Netherlands standpoint with respect to D/ISO proposal R51

GRB 40, 23-24 Sept 2004

Discussion in GRB Inf Group

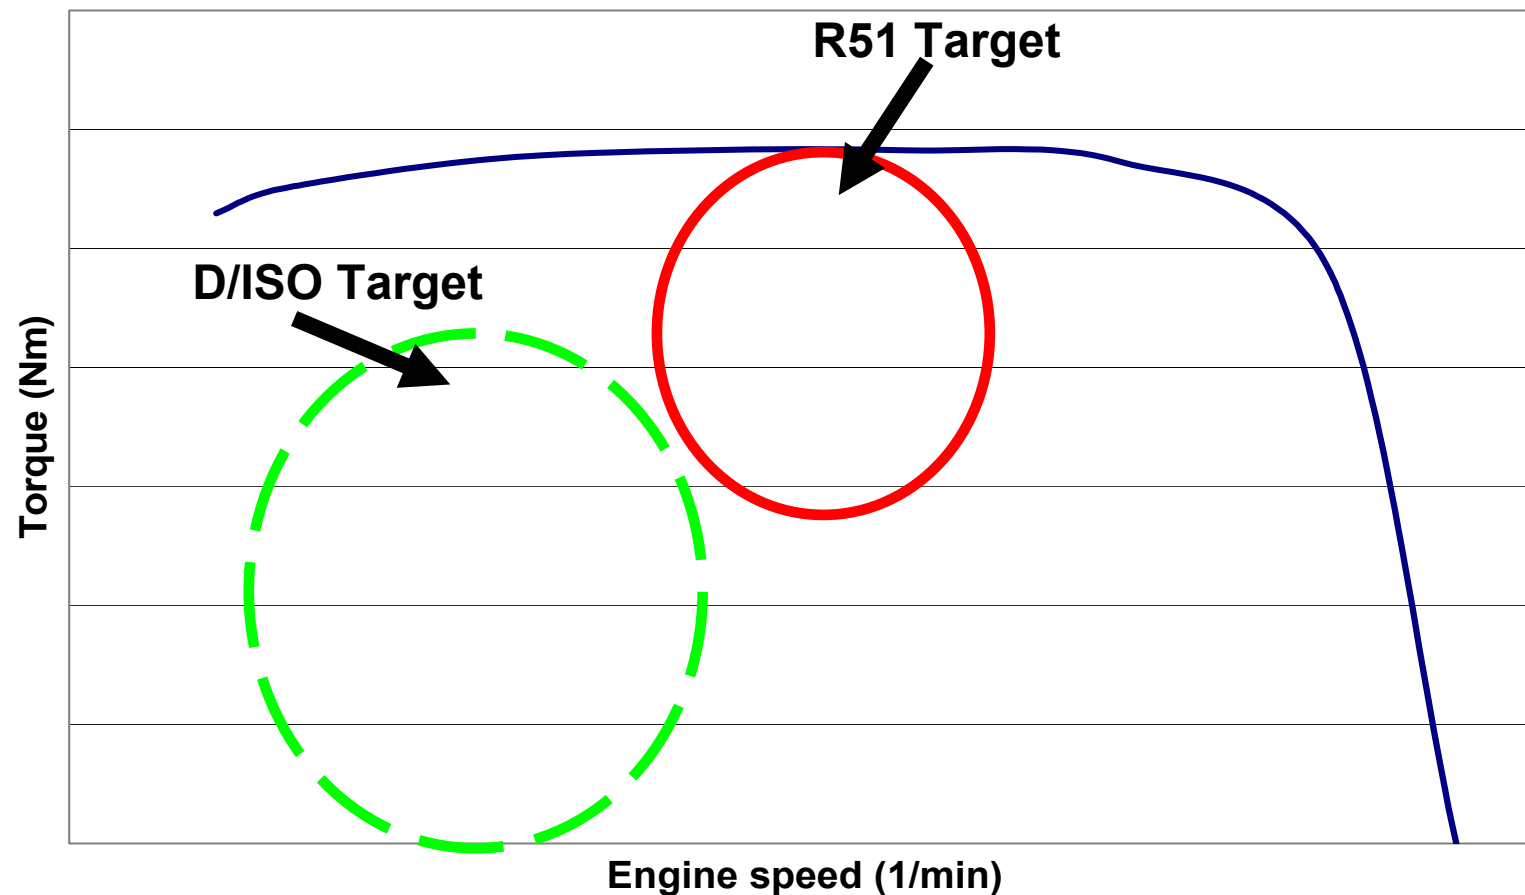
- Green (- - -) and red (—) area
- Test conditions of R51 and D/ISO

Test results: engine speed

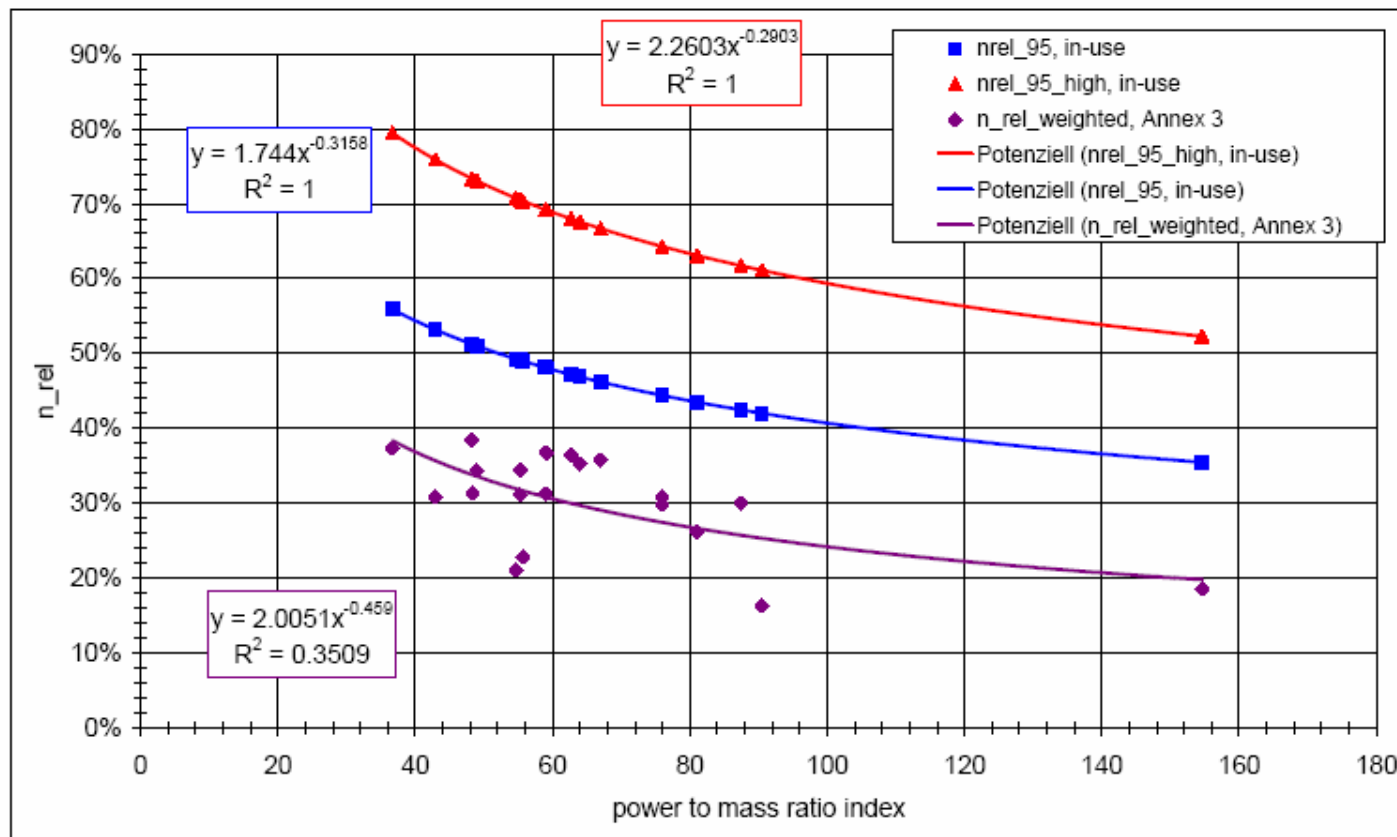
- Annex 3 much lower than urban driving

Result of Annex 3

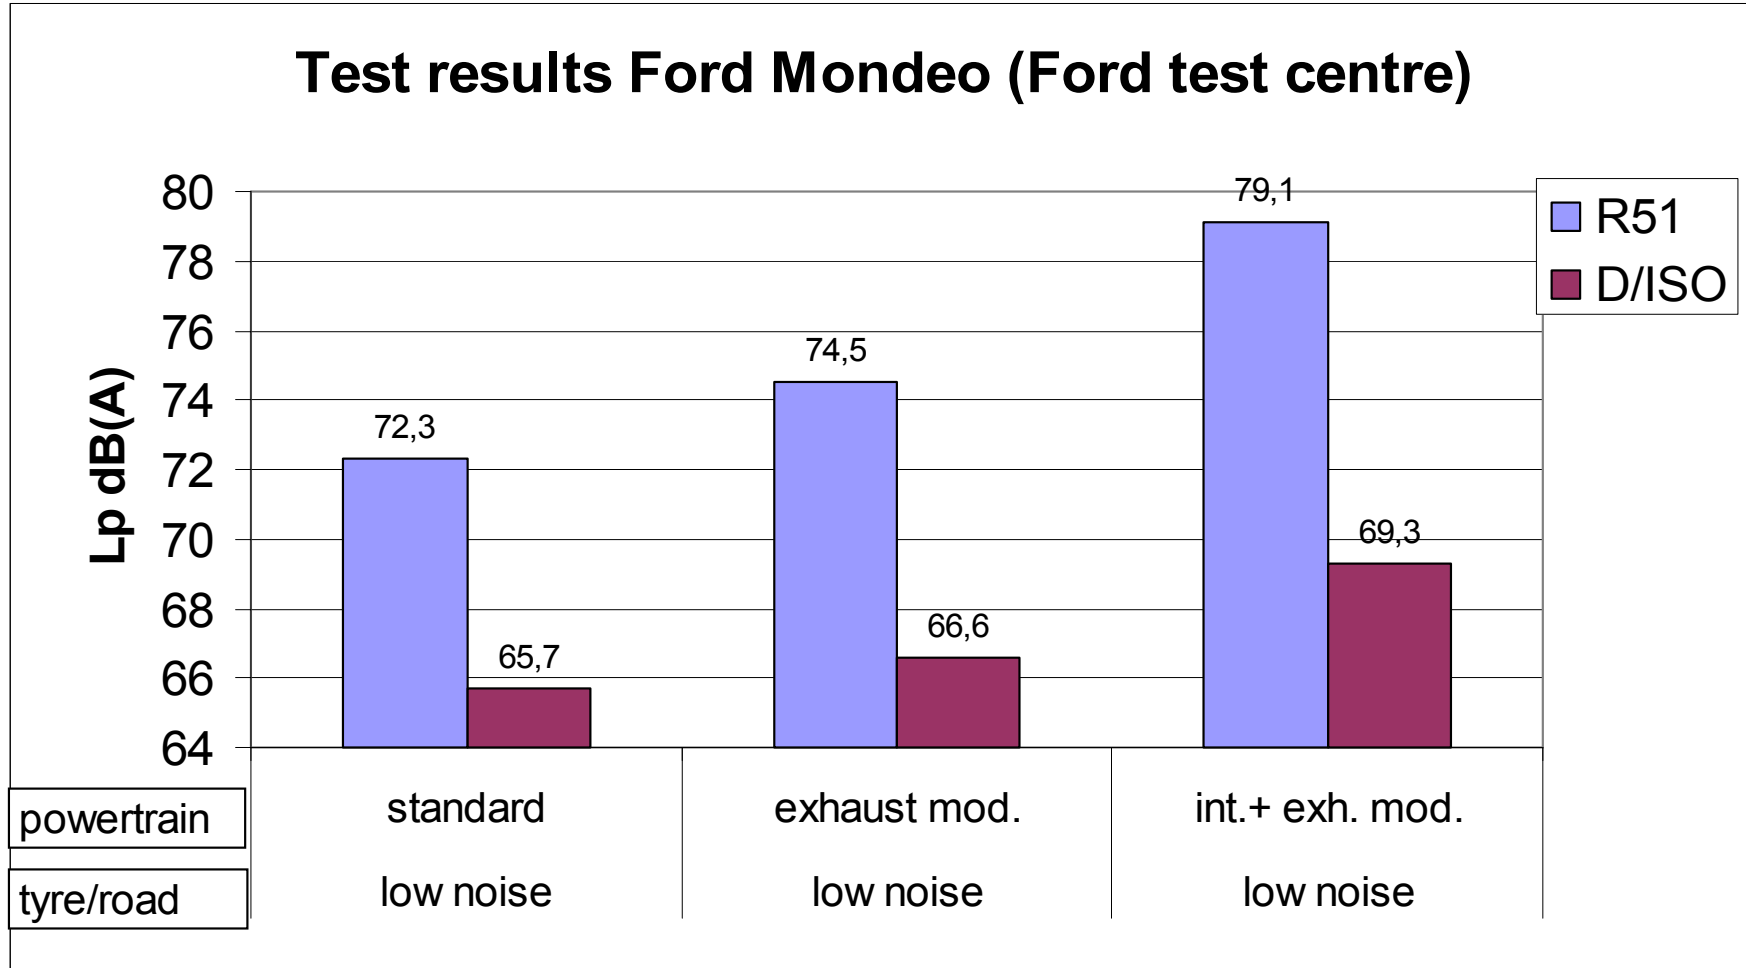
Urban driving is not good enough covered with annex 3

Annex 3 only acceptable if:
red area is covered with adequate annex 10
